e-Callisto Non Conformance Report (NCR)

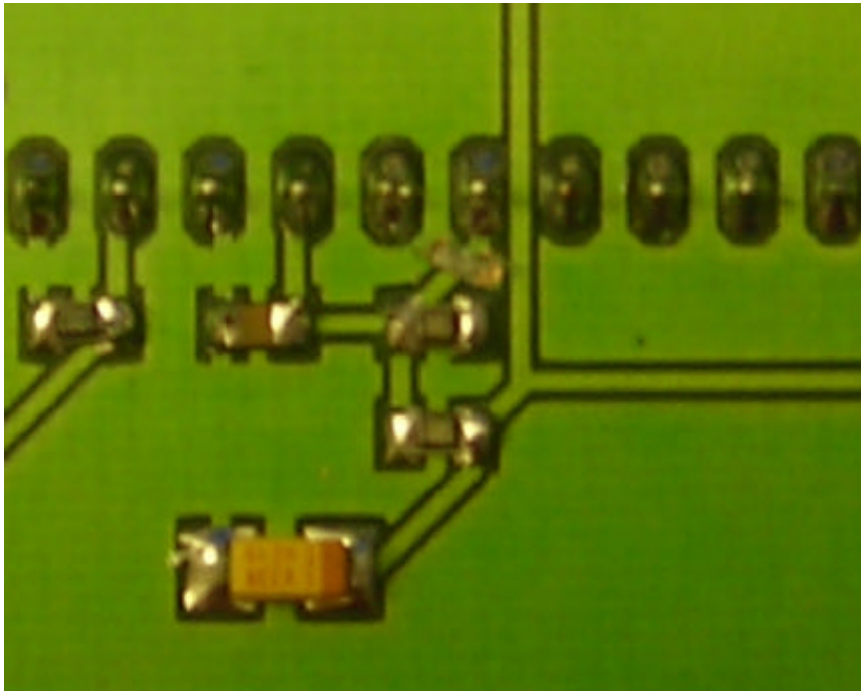
Regarding ADC reference voltage there is a fatal design error in the printed circuit board. Erroneously two different references have been connected to the input thus; a short circuit leads to a non working system.

Since we made use of external reference AREF on Pin 32, it is- according to specification- not allowed also to use AVCC on Pin 30.

In software we use `ADC_VREF_TYPE=0x00` which means:
AREF on Pin32 and internal Vref turned off.

Solution: scratch connection to Pin 30 using a scalpel or a sharp knife.

Decision: use PCB as it is, no redesign.
